DEBBIE-ANNE A. REESE
ACTING SECRETARY
FEDERAL ENERGY REGULATORY COMMISSION
888 FIRST STREET NE
WASHINGTON, D.C. 20426**Re: Response to Comments on Environmental Assessment, Newhalem Creek Hydroelectric Project (Project No. 2705-037)**

Seattle City Light Response to Intervenor Comments on FERC’s Environmental Assessment of the proposed decommissioning of the Newhalem Creek Hydroelectric Project (FERC No. 2705-037) dated March 29, 2024

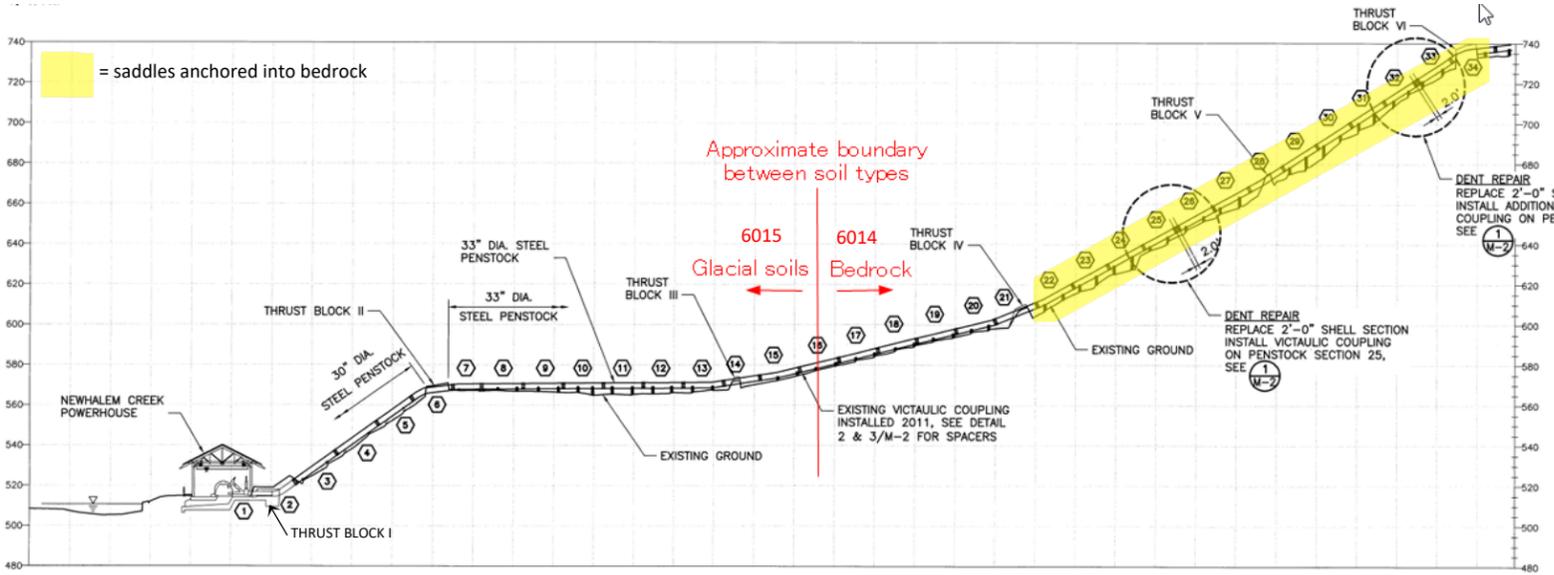
NPS-56 Page 14	<p><u>Penstock long-term stability</u> The Partial Removal Alternative of the EA and Decommissioning Plan is deficient in addressing the penstock’s long-term maintenance, stability, and the impacts of vegetation management. Factors that were not assessed include: 1) the effects of precipitation and soil erodibility on penstock stability, 2) existing condition of above ground penstock cradles and supporting structures, 3) corrosion of concrete penstock cradles, and 4) impacts to terrestrial habitat related to hazard tree management. When combined, these factors indicate that the long-term stability of the penstock will require significant levels of</p>	<p>As the FERC EA describes in Section 3.2: under the proposed alternative, “[r]outine vegetation maintenance along the penstock would cease, which would result in the restoration of the adjacent corridor to forested habitat. Vegetation would be removed only in the immediate footprint and only as necessary to repair or paint the penstock. Painting of the penstock would occur approximately every 10 to 20 years.” The penstock is well vegetated currently, and erosion is not occurring, so it is unlikely that erosion would occur in the future when vegetation maintenance will cease and forested conditions are present, affording the hillslope even further protection. Most of the saddles that would be exposed to the elements were recently replaced according to a robust design with lasting materials (see response to comment NPS-56ab below). As provided in response to comment NPS-53, City Light would only manage trees that were an immediate threat to the facility and would work with the Section 106 consulting parties to determine which situations would require tree management, if any. City Light has trained staff who manage trees year-round using recognized BMPs for personnel safety. As provided in response to comment NPS-57, City Light has not limited penstock painting to every 10-20 years. City Light would not repaint according</p>

Comment #	Comment	City Light Response
	<p>maintenance to ensure the integrity of the structures, negatively impact forest structure and wildlife habitat, and place personnel at unnecessary risk when managing hazard trees.</p>	<p>to a prescribed timeframe but would utilize onsite painting staff to assess the need based on the penstock's condition to preserve the integrity of the structure.</p> <p>City Light believes the above is a credible plan for future maintenance of the penstock based on knowledge of the penstock's history and current conditions. Impacts from erosion would be negligible and effects to the forest structure and wildlife habitat would only be to the 3-foot-wide footprint of the penstock for its approximate 700-foot length outside of the adit.</p>
<p>NPS-56ab Page 14</p>	<p>The penstock and its associated saddles are placed on steep slopes in two sections of their length below the tunnel. The upper section of the penstock is constructed over more stable soils and bedrock (Map Unit Symbol 7003, Figures 1 and 2) however, the lower section above the Powerhouse is composed of loose glacial deposits (Map Unit Symbol 6015, Figures 1 and 2) which is the area of greatest concern due to its high erodibility.</p>	<p>City Light notes that there are inconsistencies between the conclusions in this comment and NPS-58a below and clarifies that the penstock and saddles only occur in soil units #6015 (at the lower end of the penstock) and #6014 (at the upper end of the penstock). In this comment, the NPS states that the upper end of the penstock lies on stable soils, whereas #NPS-58a states that the upper end of the penstock is in soils with high erosion potential. In fact, soil unit # 6015 is primarily Tricouni (50%) and Ragged (25%) soils, which have erodibility factors (Kf) of 0.28 and 0.20 respectively. Tricouni is moderately susceptible to erosion and Ragged is low susceptibility. Thus, a moderate-to-low susceptibility is a more accurate starting place before considering the positive factors like the healthy vegetation cover and gentle slope. Soil unit #6014 is similar, composed of 40% Thorton with a moderate erosion susceptibility (Kf = 0.32) and 25% Ragged with low susceptibility as described above. The saddles constructed on steep slopes in soils with higher erosive potential, which is still only low-to moderate erosion, are anchored into bedrock.</p> <p>The penstock saddles were constructed in 2016 with rebar reinforced concrete. Each saddle was either built on top of bedrock and secured to the bedrock with rock anchors, or on top of a 6'-6" x 4' x 10" concrete foundation with a minimum depth of 1'-6". City Light is confused that there is concern over the lower half of the penstock. Although this location is indeed composed of glacial deposits, most of the lower penstock is situated on level ground, with only a small segment, less than 80 feet, on sloping ground (see figure below), with substantial concrete thrust blocks (mounted on level ground) stabilizing it on each end. Dead, hydraulic, seismic, snow and wind loads were considered when designing the saddles. City Light is not concerned about the stability of the penstock.</p>
